Accessible Pedestrian Signals: Intersection Planning Sheet

ADDENDUM / REVISIONS

US 40 / SR 72 INTERSECTION IMPROVEMENTS

SIGNAL PLAN US 40 (PULASKI HWY) SR 72 (WRANGLE HILL RD / SUNSET LAKE RD)
 SHEET NO. 175
 TOTAL SHTS. 179

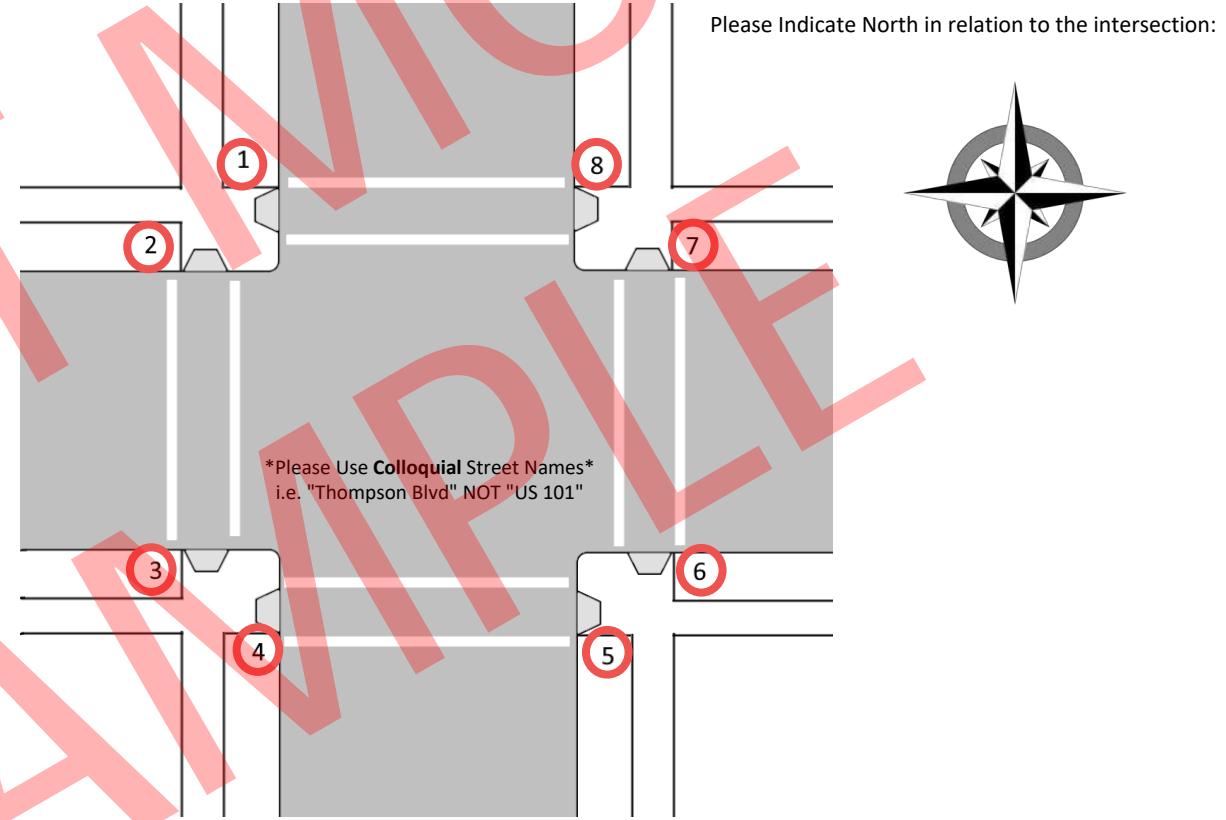
~~• Per MUTCD 4E.10: Pedestrian stations with <10' separation will use CUSTOM message for the walk cycle.~~
~~• Pedestrian stations with > 10' of separation will utilize a PERCUSSIVE (TONE) for the walk cycle.~~

Please include **NIGHT MODE** instructions on all future orders via *Signal Construction* and *Signal Maintenance*.

SHEET NO.	174
TOTAL SHTS.	179

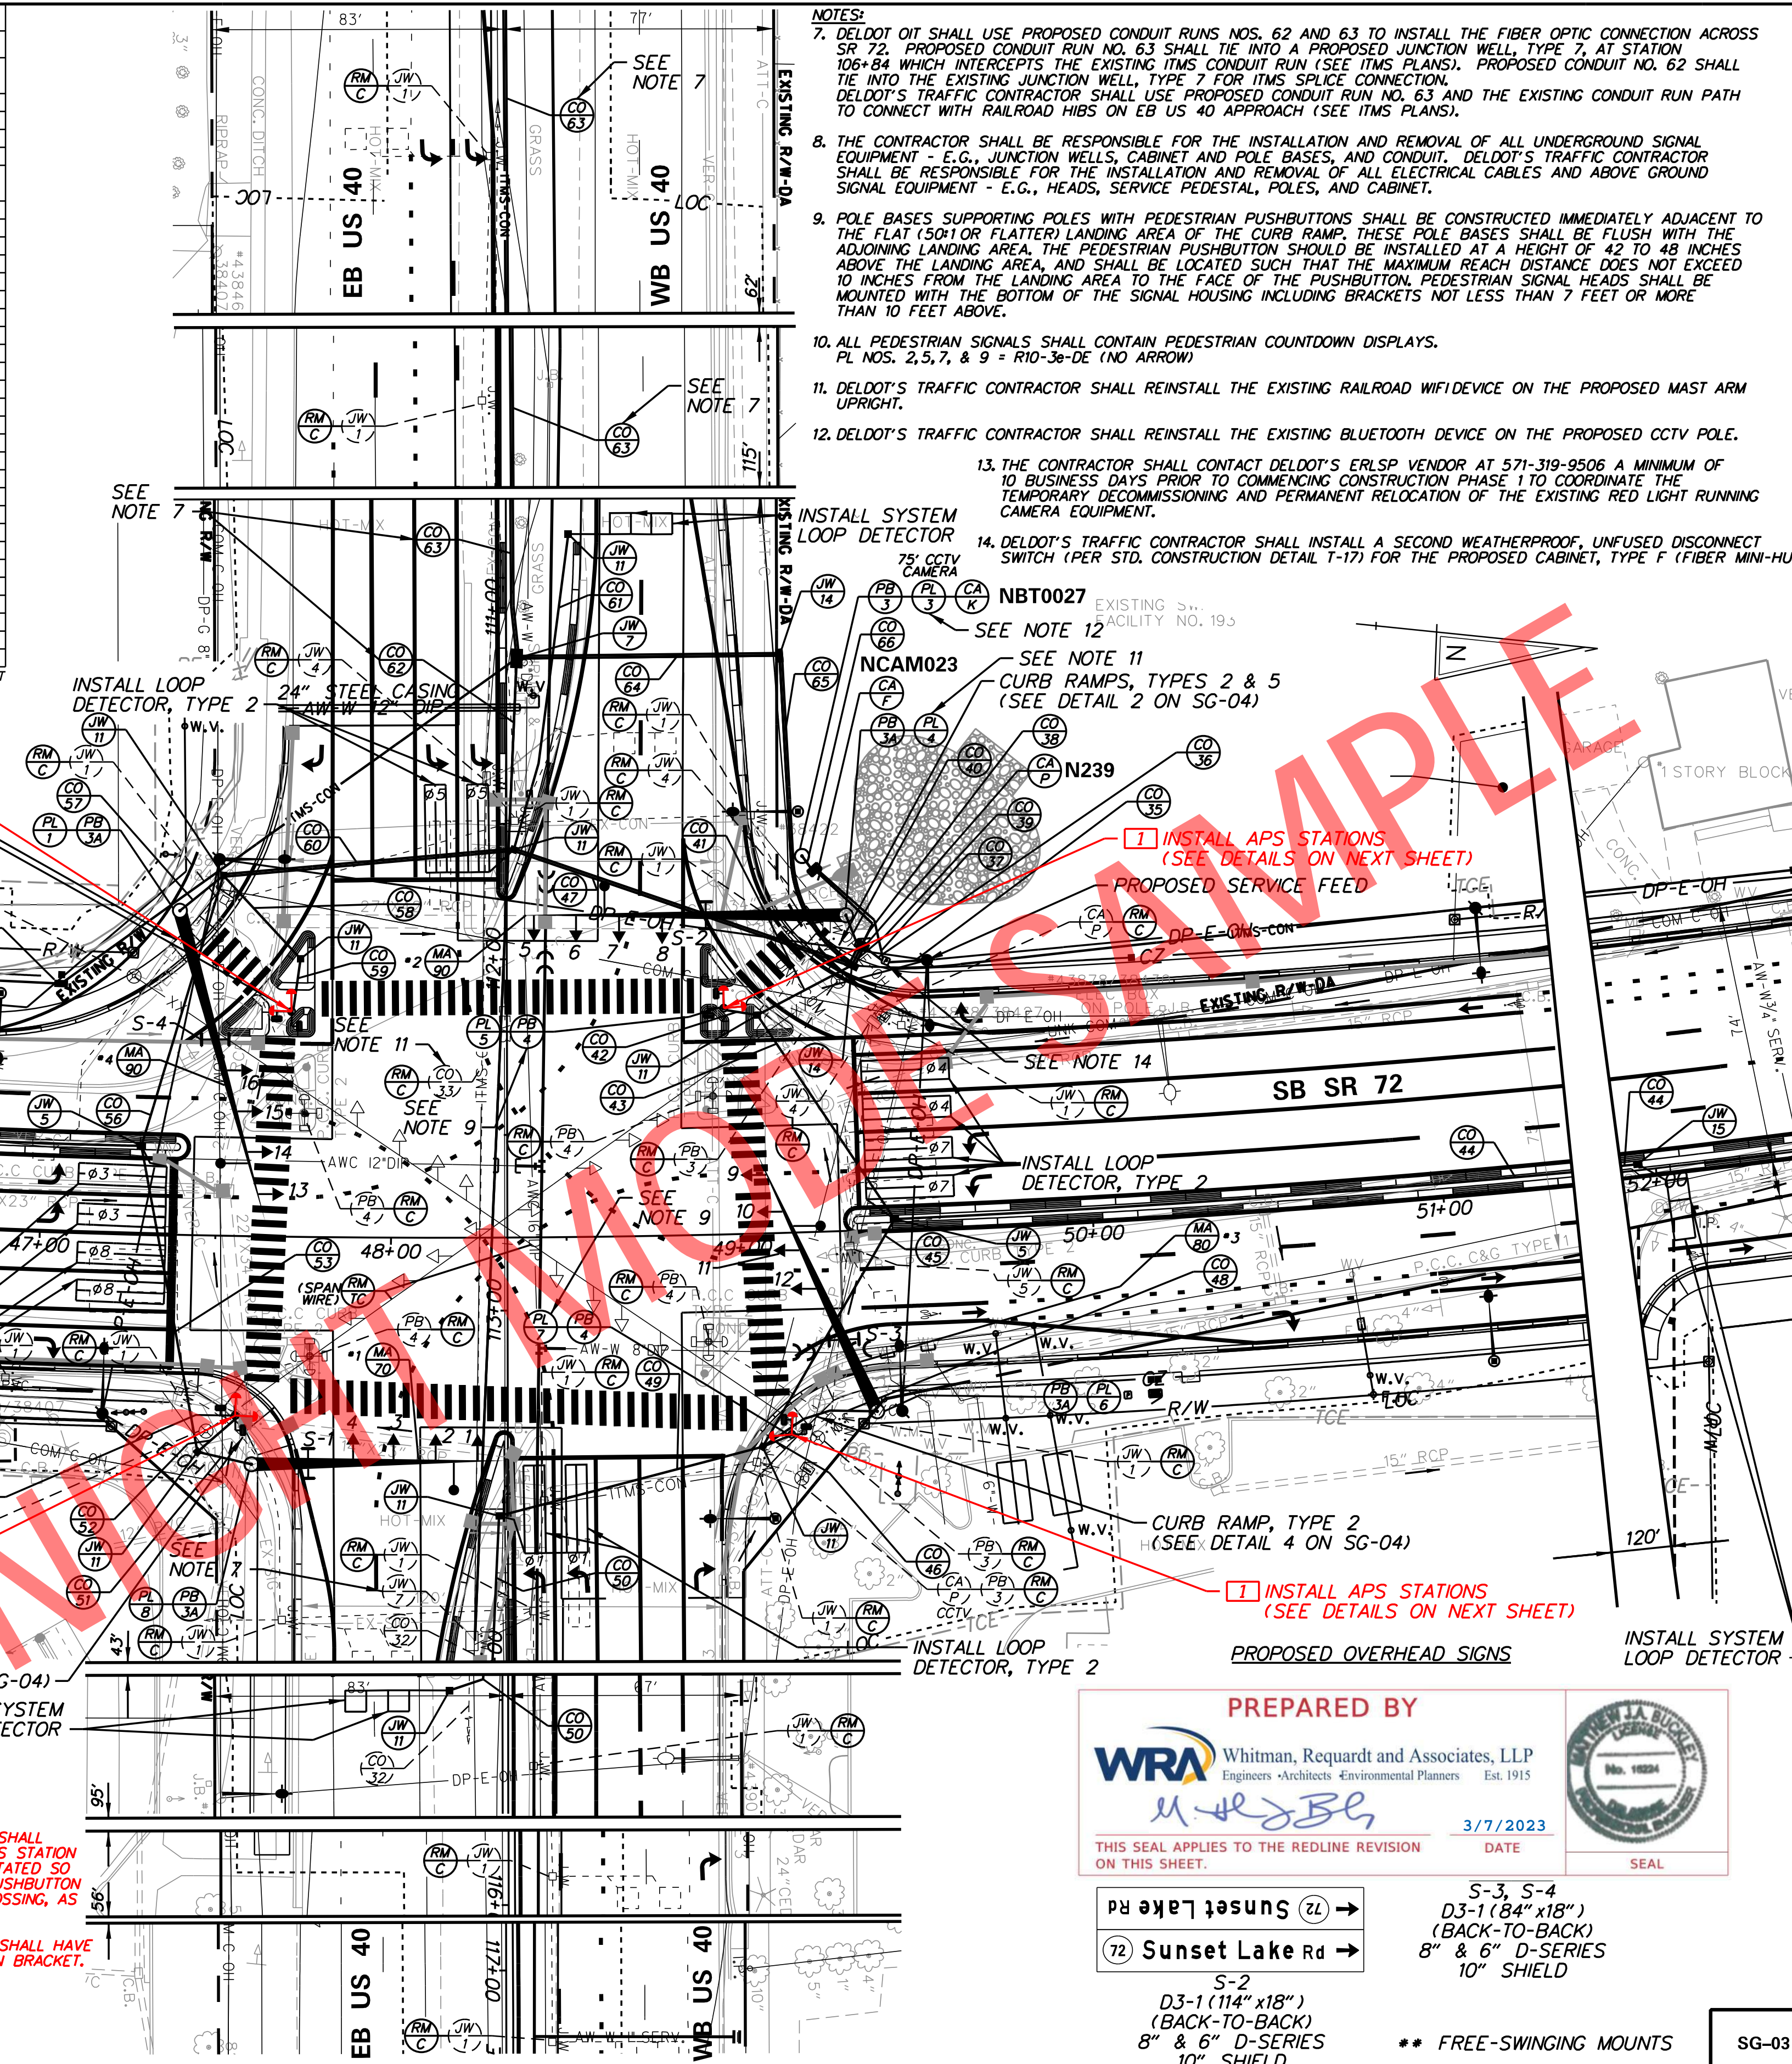
PREPARED BY
WRA Whitman, Reardon and Associates, LLP
 Engineers • Architects • Environmental Planners Est. 1915
 M.J.B.
 THIS SEAL APPLIES TO THE REDLINE REVISION ON THIS SHEET.
 3/7/2023 DATE
 SEAL

1. INSTALLED APS STATIONS AND PEDESTRIAN WARNING SIGNS. B. WALKER (WRA) 02-2023 (P.O. #65506/443055)

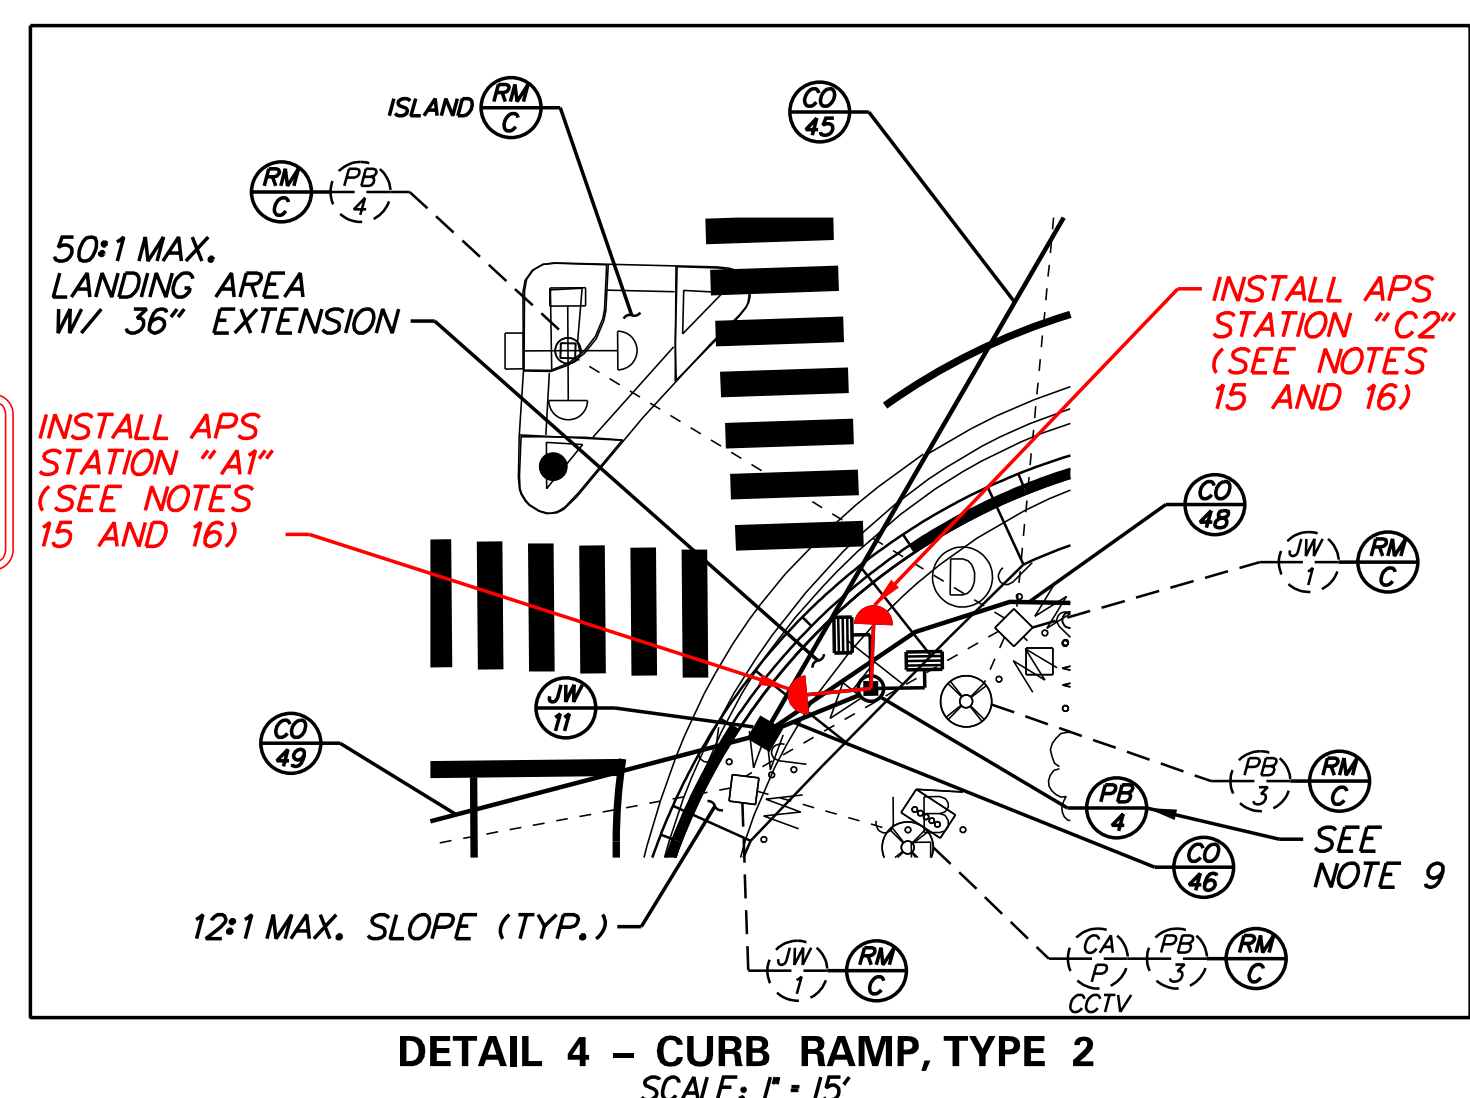
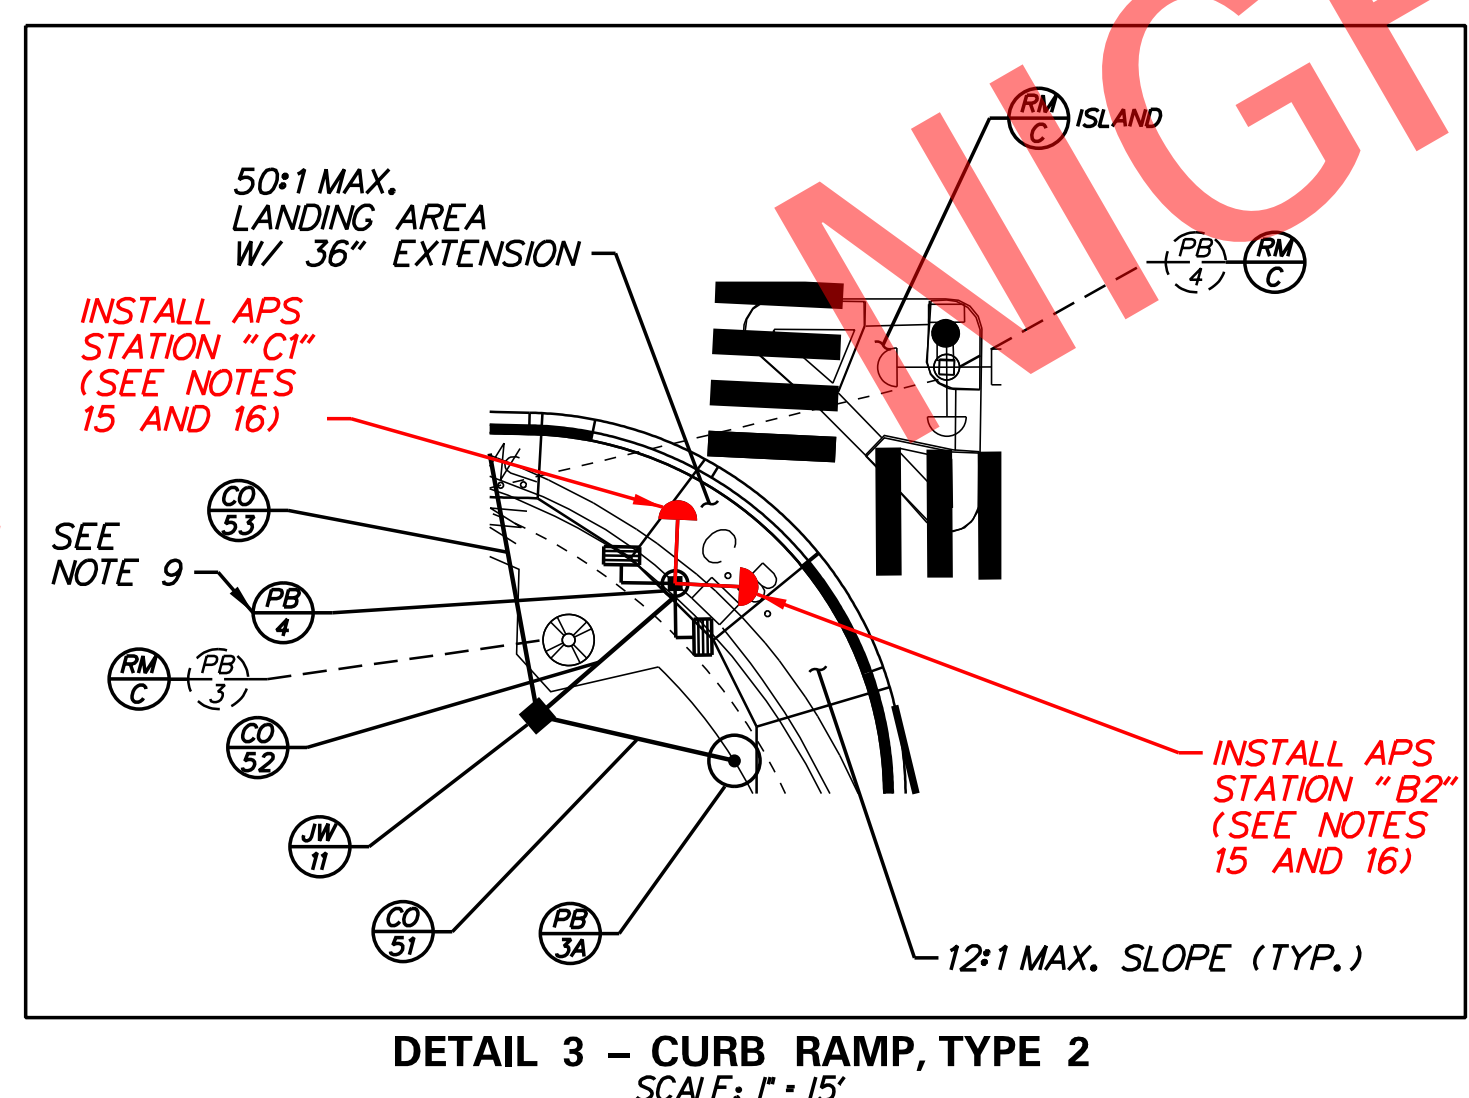
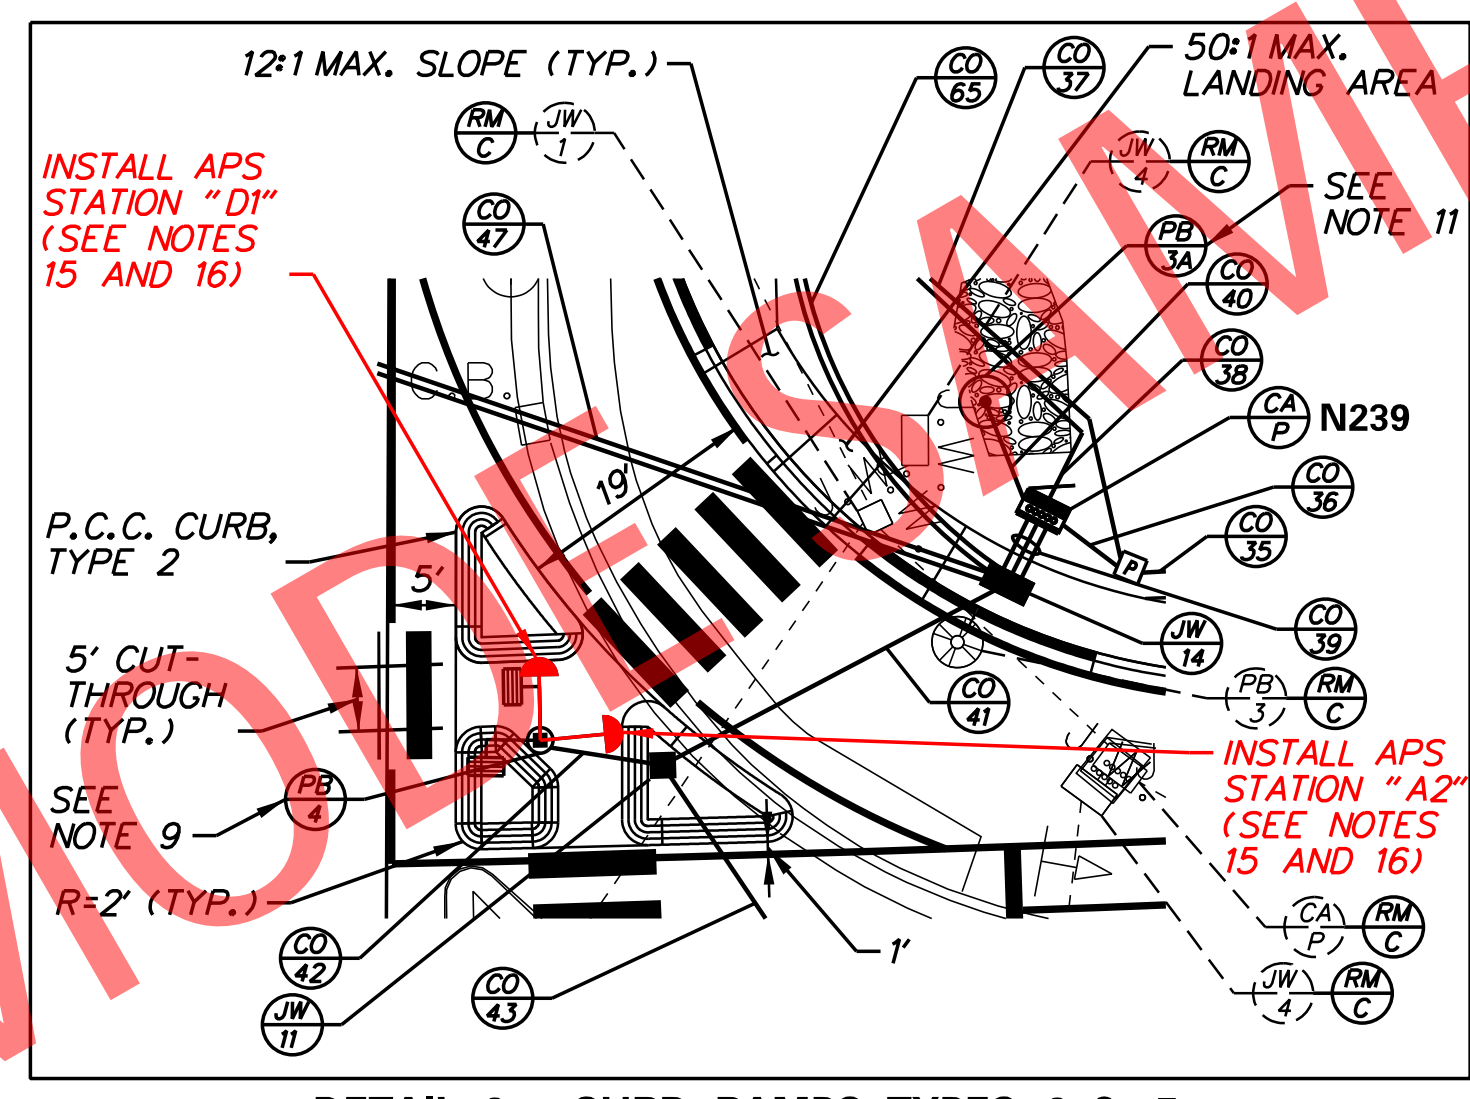
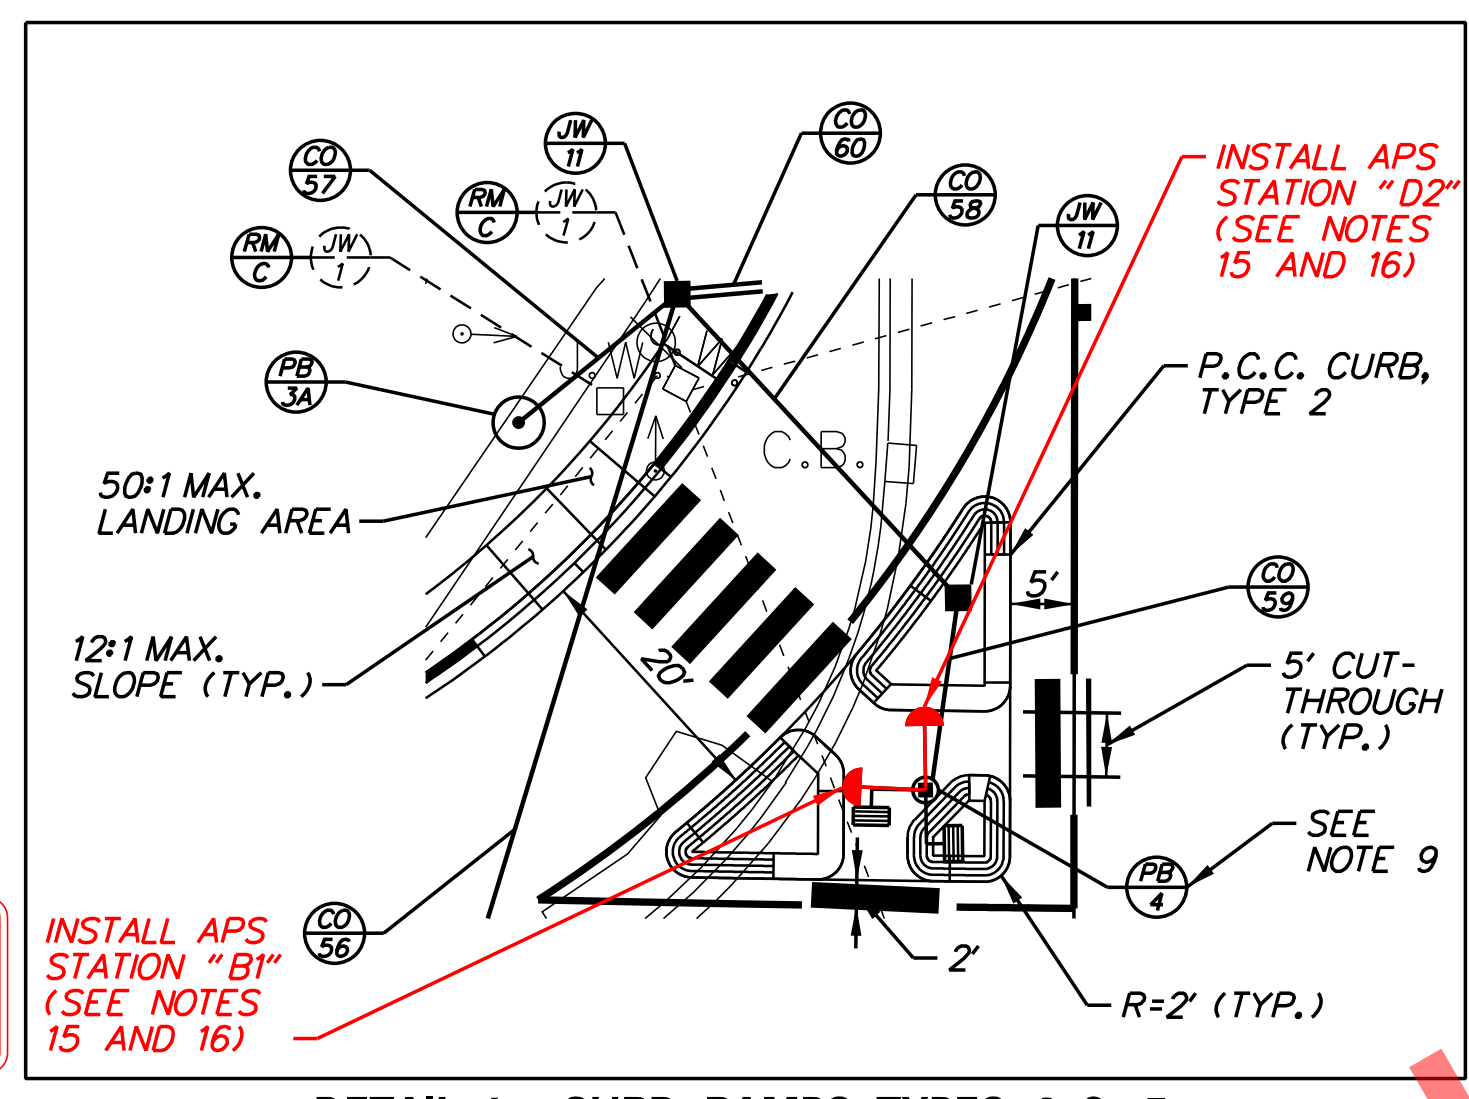
- THE TRAFFIC CONTRACTOR SHALL INSTALL THE PROPOSED APS STATION WITH THE PUSHBUTTON ROTATED SO THAT THE FACE OF THE PUSHBUTTON IS PARALLEL WITH THE CROSSING, AS SHOWN.

- THE PROPOSED ASSEMBLY SHALL HAVE AN APS STATION EXTENSION BRACKET.

INSTALLED APS STATIONS AND PEDESTRIAN WARNING SIGNS.
 B. WALKER (WRA) 02-2023
 (P.O. #65506/443055)
